COMMON POSITION PAPER

16th May 2025

**Comments & Answers on
Questionnaire on LDAR minimum detection
limits and first step underground leak
thresholds in the EU Methane Regulation**

To:
DG ENER C2 Methane Regulation team
ENER-METHANE-REG@ec.europa.eu

Figure 1: Suction Probe Application

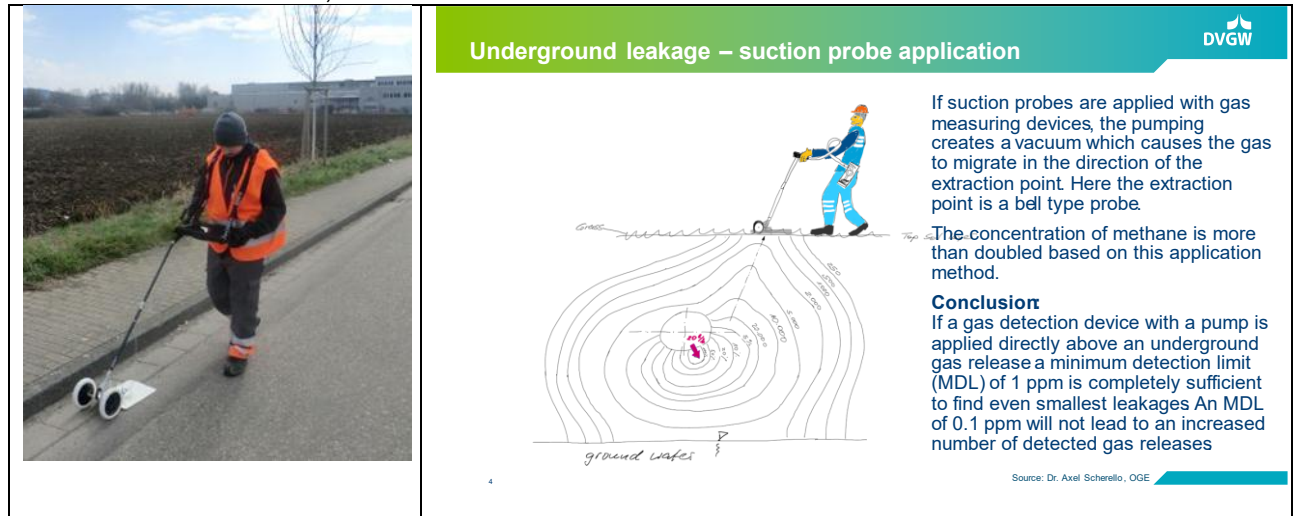
According to DVGW Worksheet G 465-4, the minimum detection limit for hand-held devices with carpet probe and suction is 1 ppm. For leak detection in step 1, the devices are e. g. equipped with semiconductive, heat conduction, flame ionisation or laser absorption detectors.

Once a threshold value of approx. 5 ppm is reached, the next step is to drill and measure the gas concentration in the boreholes. Once the gas concentration reaches 1,000 ppm, the leak is repaired.

This is a proven and documented procedure that has been used for decades and has contributed to the high quality of German gas infrastructure. Setting the minimum detection limit at 0.1 ppm means that this technology is excluded from leak detection in accordance with the MER without there being any technical reason for this, as both technologies – i.e. detection using a vehicle and detection using a carpet probe and suction – are equivalent. This is explained by the fact that when detection is carried out using a carpet probe and suction, the floor air is sucked directly from the cracks and joints and the gas concentration is much less diluted than when measuring with a vehicle in the gas plume. For this reason, the minimum detection limit of 1 ppm is sufficient for the hand-held carpet probe with suction.

Figure 2: Different Measurement Point

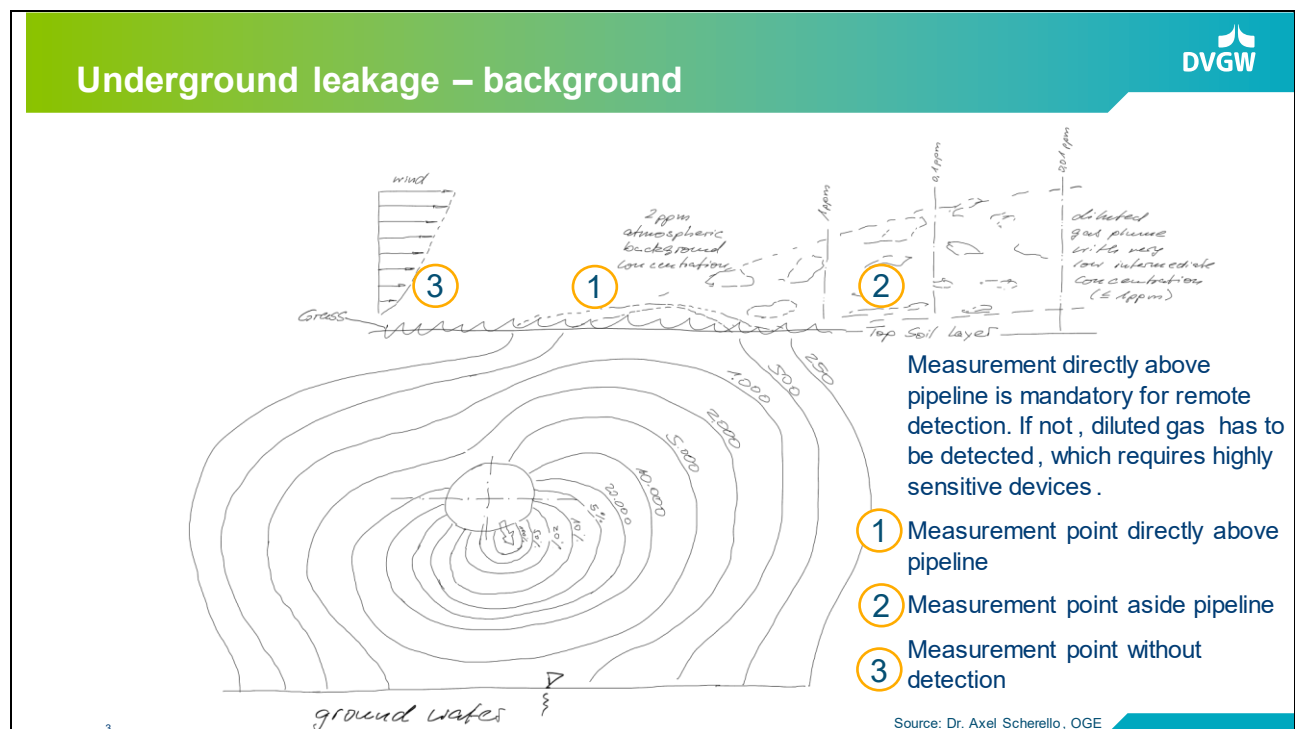
For measuring leakages from underground components, three different measurement points should be differentiated (see figure 2).

In Germany, measurement with an MDL of 1 ppm directly above an underground component is the most commonly used procedure. This procedure leads to detection success rates of 100%. Therefore, from our point of view, an MDL of 1 ppm at such measurement points (i.e. measurement point 1, see figure below) is entirely sufficient. Even for vehicles with an MDL of 1 ppm or better and a gas inlet close to the surface that are driving directly over the pipeline a successful detection is proven. (EvaNeMeL⁵)

Whereas, for inspections at measurement point 2 in a diluted gas plume a better sensitivity and an MDL of e.g. 0.1 ppm is required.

A measurement at point 3 at the upwind-side will not be successful. This is the reason why detection by vehicles aside the pipeline might lead to uncertainties described by Picarro. (EvaNeMeL)

In abstract 3.3.2.2, point 3 the European Commission states that “a required leak detection threshold of 1 ppm would result in 85% of leaks from underground components remaining undetected”. The Commission concludes that “a required MDL of 1 ppm should therefore not be proposed”. Yet, the Commission is wrong with this generalisation. It is important to underline that such high rates of undetected leaks only appear in the case of leak detection by vehicle in a diluted gas plume. The graphs generated by Picarro (see graphic 1 in Annex 1 of the consultation document) do not show the case of handheld carpet probes, as Picarro's evaluation refers to the measured values in a gas plume. Picarro themselves confirmed upon request that the interpretation shown in the consultation document is incorrect. So, it is not correct that 85% of leaks can't be found in direct ground-based leak detection using the carpet probe with suction. We emphatically urge the European Commission to take the necessary differentiation and to clarify the application area of the Picarro graphs in order to avoid misinterpretation and misleading guidance for policy recommendations.

For the reasons mentioned above, we propose the following minimum detection limits and leak thresholds for LDAR inspections of underground pipelines:

- Minimum detection limit ≤ 0.1 ppm
- Leak threshold for the initiation of step 2 (measurement in the gas plume) 0.5 ppm

- Minimum detection limit 1 ppm
- Leak threshold for the initiation of Step 2 (measured with carpet probe and suction) 10 ppm

Underground leakage – suction probe application

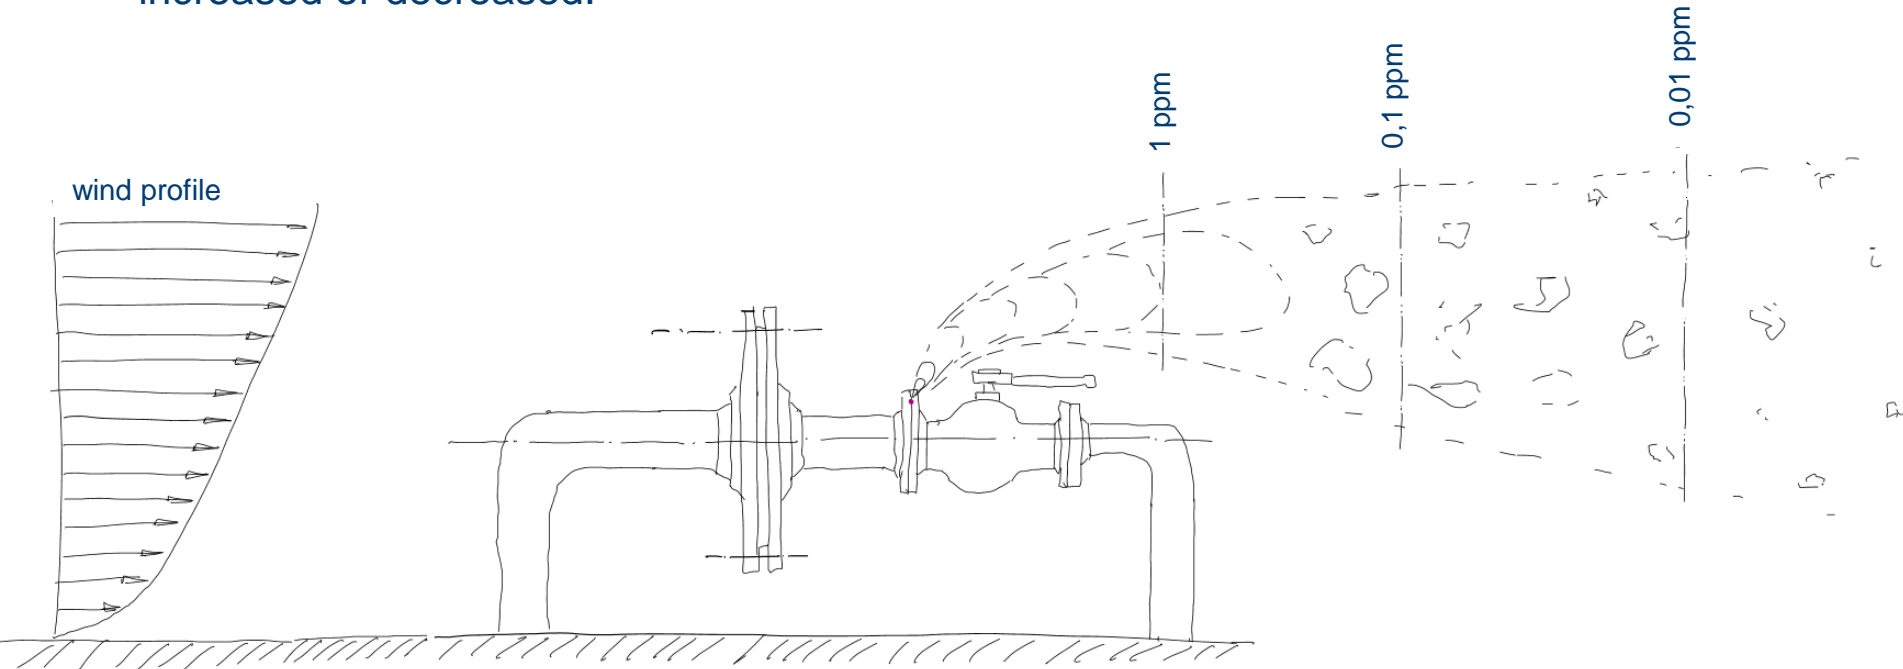
If suction probes are applied with gas measuring devices, the pumping creates a vacuum which causes the gas to migrate in the direction of the extraction point. Here the extraction point is a bell type probe.

The concentration of methane is more than doubled based on this application method.

If a gas detection device with a pump is applied directly above an underground gas release a minimum detection limit (MDL) of 1 ppm is completely sufficient to find even smallest leakages. An MDL of 0.1 ppm will not lead to an increased number of detected gas releases.

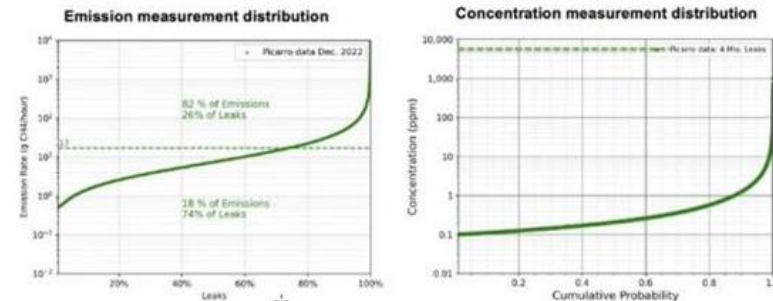
The current dataset include all measurements performed by Picarro until December 2022 with PCubed EQ version 6.5.

Statistics of Picarro are related to concentration measurements of diluted gas in several meters distance of a release point.

Using handheld devices with MDL 1 ppm and a suction probe will find every gas release, if applied close to source.

Lower MDL for handheld devices with suction probe will not lead to better or more detections!
